Grabbs Lot 27 SB

Plans Submittal ONLY

FLOOR PLAN
SCALE: 1/4" = 1'-0"

LOT 27 Shepherds Bluff

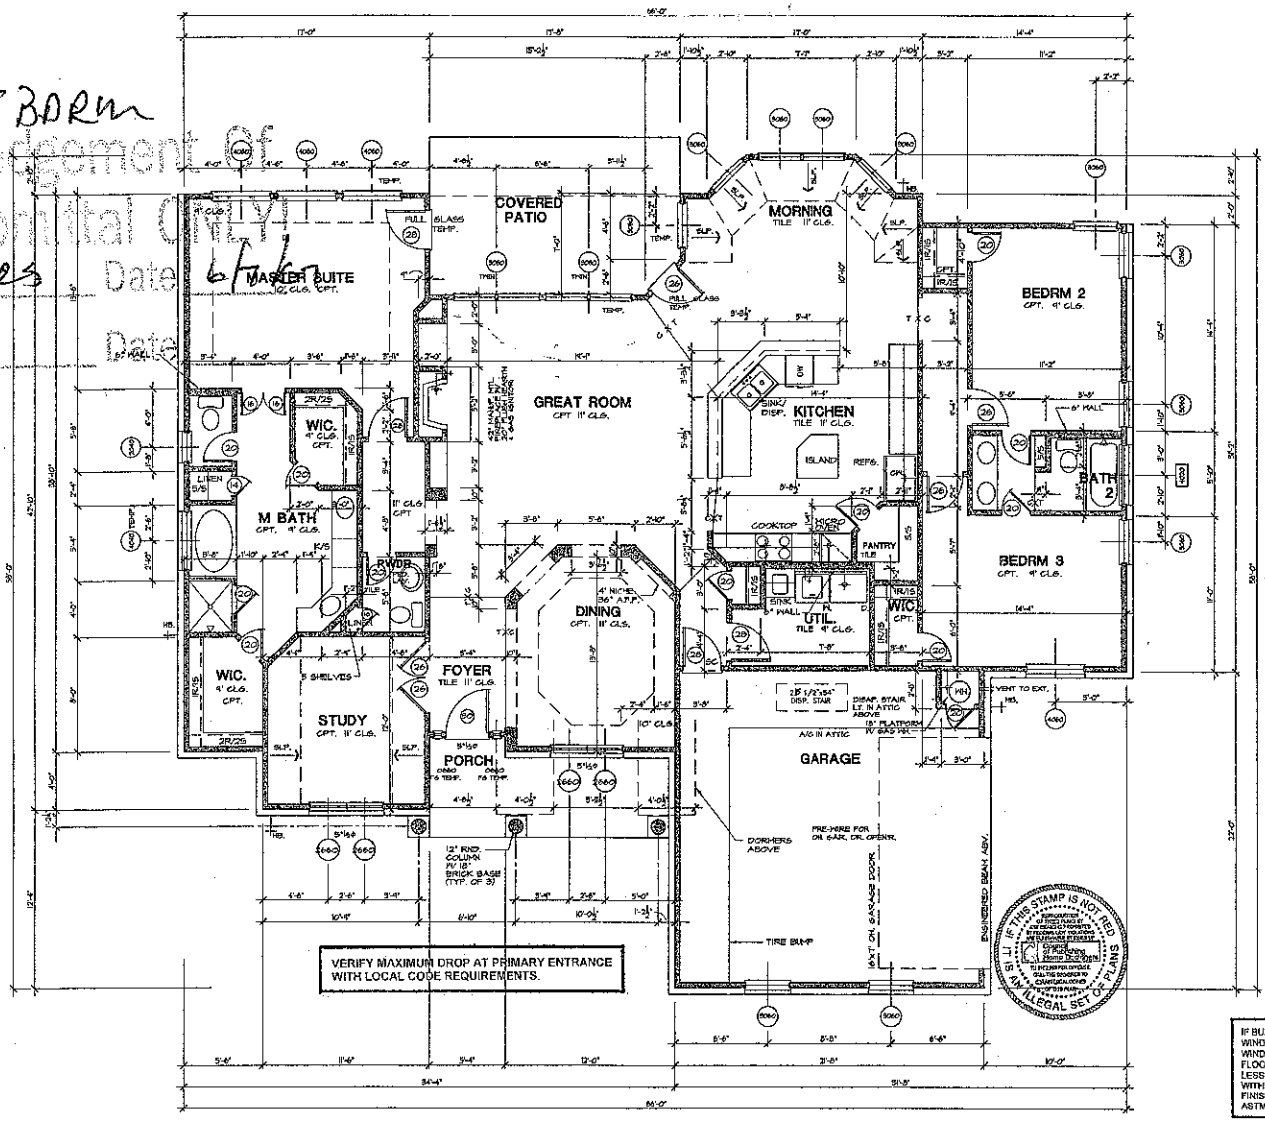
IF BUILDING UNDER IRC 2006:
WINDOW GUARDS REQUIRED AT SECOND FLOOR WINDOWS LESS THAN 24 INCHES ABOVE FINISH FLOOR AND AT ANY FIRST FLOOR LEVEL WINDOW LESS THAN 24 INCHES ABOVE FINISH FLOOR AND WITH A SILL GREATER THAN 72 INCHES ABOVE FINISH GRADE. WINDOW GUARDS TO COMPLY WITH ASTM F 2006 OR F 2090.
